Change Notice Number  
TPA-CN- 656

TPA CHANGE NOTICE FORM

Document Number, Title, and Revision:  
SGW-56993, Sampling Instruction for the 300-FF-5 Operable Unit  
Supplemental Post ROD Field Investigation, Rev 0

Figure 3. Location of Existing Groundwater Wells 399-1-17A and 399-1-55 and Proposed Boreholes

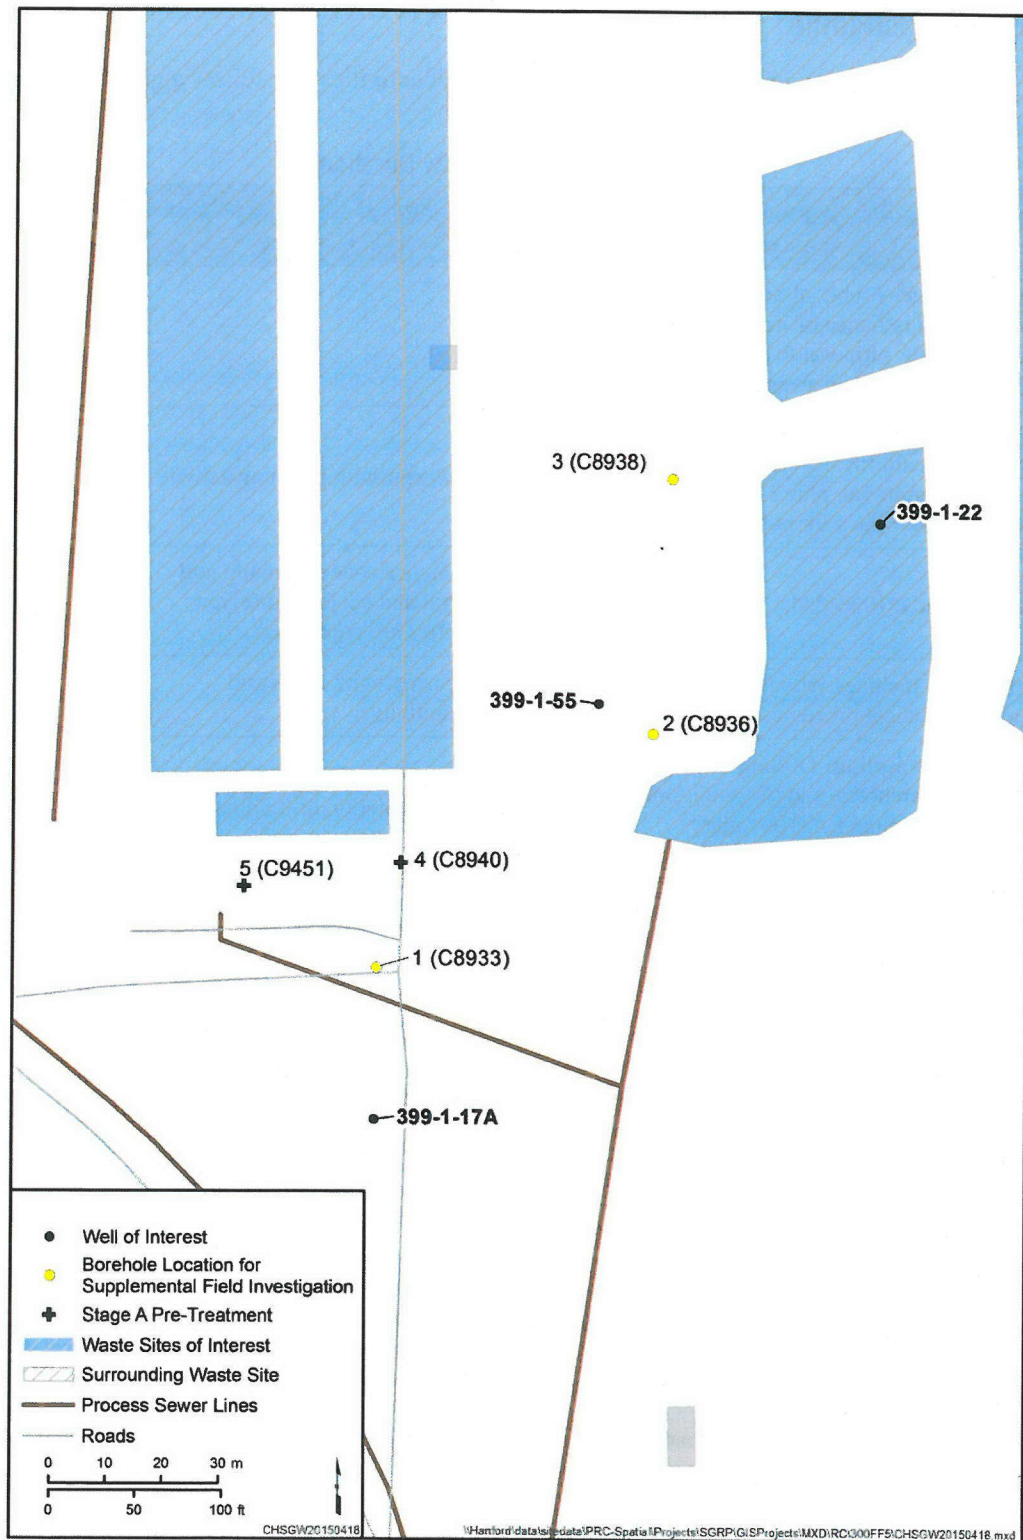
Document is being updated to include two additional borehole locations that have been selected for pre-treatment sampling. Figure 3 has been updated. Table 3 was updated to include the addition of two new boreholes. Tables 4 and 5 have been updated with the additional borehole identifications.

Selected pages from the above mentioned sampling instruction have been modified to add two wells for pre-treatment sampling. A new figure has been generated that includes the location of the two additional wells. Added text is double-underlined and deleted text has been identified by ~~strikethrough~~.

Two wells are needed for additional pre-treatment sampling after the selection of the refined enhanced attenuation area (EAA) as per Principal Study Question 2a. The two additional wells will provide needed information for the characteristics of the vadose zone within the EAA prior to treatment for uranium sequestration using the polyphosphate solution. Figure 3 was updated to reflect the locations of these two wells in relation to the wells of interest referred to in this sampling instruction.

Results from samples collected at the initial three borehole locations was used to further refine the location of the EAA. Two additional boreholes have been selected for pretreatment sampling within the new boundary, and will be used to provide information for PSQ 2a, regarding the leachability characteristics of the PRZ and vadose zone. Tests performed on soils from the two new boreholes will be used to document the pre-treatment leachability characteristics of the vadose zone and PRZ within the EAA.

Proposed borehole locations are shown on Figure 3, with the estimated NAD83, *North American Datum of 1983*, coordinates provided in Table 4.
